PASADENA HEIGHTS / EDISON WEST SUBDIVISIONS PRELIMINARY OVERALL AREA DEVELOPMENT PLAN	
DRAWN BY: J.E.H. CHECKED BY: S.L.	DATE: 2/8/99 JOB NO.: 158401	M.W. CUDE ENGINEERS, L.L.C. CIVIL ENGINEERS & SURVEYORS (210) 681-2951 MAILING ADDRESS: 10325 BANDERA RD., SAN ANTONIO, TEXAS 78250 LOCATION: 10325 BANDERA RD., SAN ANTONIO, TEXAS 78250	DATE: _____ DESCRIPTION: _____ SHEET 1 OF 1

Re: Pasadena Heights

POADP # 627

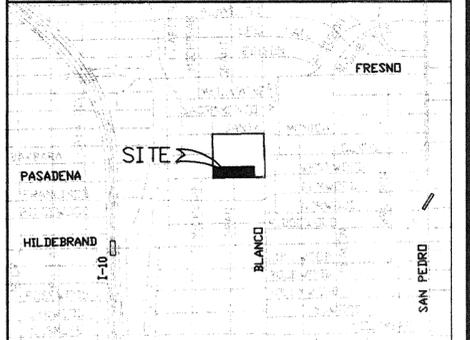
- Based on the topography, a Flood Plain Study and drainage review will probably be required during the platting process.
- A variance may be required for the northern most Local Type A Street, because the centerline is less than 125 feet from the centerline of Santa Anna.

- A variance may be required for the property line radius for the two 90 degree elbows on the proposed Local Type A streets, which require at least 25 feet.

- A variance may be required for the 90 degree elbows, which are extending into private property.
- This development will need to comply with tree preservation ordinance #85262. For information about these requirements you can contact Building Inspections at 207-7102.

- It will be expected that you will plat all of the property depicted in your POADP, to include: floodpains, drainage areas and open space.
- I would encourage you to work closely with the school district, so that they can plan accordingly.
